Service Bulletin

SR-055

SUBJECT: Potential Incorrect Fan Wiring on ASUF and ASPT Air Handlers

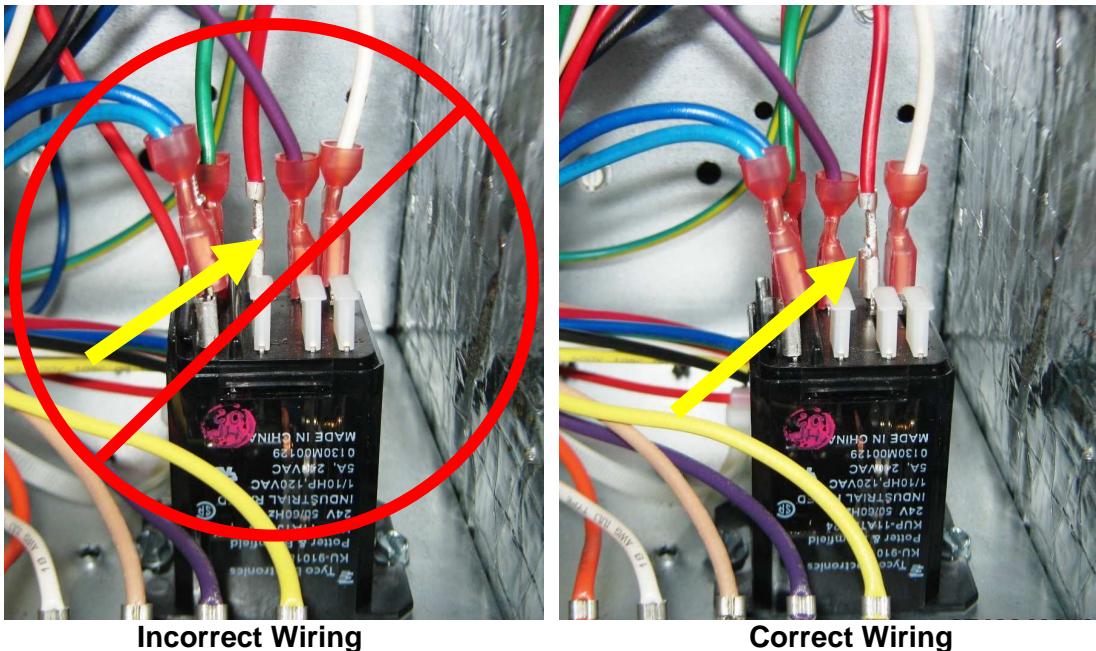
We have recently discovered that a small group of ASUF and ASPT air handlers with serial numbers from 1303129141 to 1306724076 were found to have been miss-wired in the factory. If this occurs the electric heat can remain energized with no call from the thermostat. The heater limits will prevent the electric heaters from remaining on.

1. Remove the upper access panel and visually check to see if the relay B1370752 relay or 0130M00129 relay is used; see the pictures on the right.
2. If relay B1370752 relay is used, then wiring is correct. Repackage unit. If the 0130M00129 is used continue to step 3.
3. Using the following pictures for reference the Red wire should be on the second terminal from the right and the purple wire should be on the third terminal from the right as seen in the picture on the right.

4. If found incorrect remove the purple and red wire and swap them. Red wire should be on terminal 4 (second from the right) and purple should be on terminal 7 (third from the right).
5. Repackage Unit
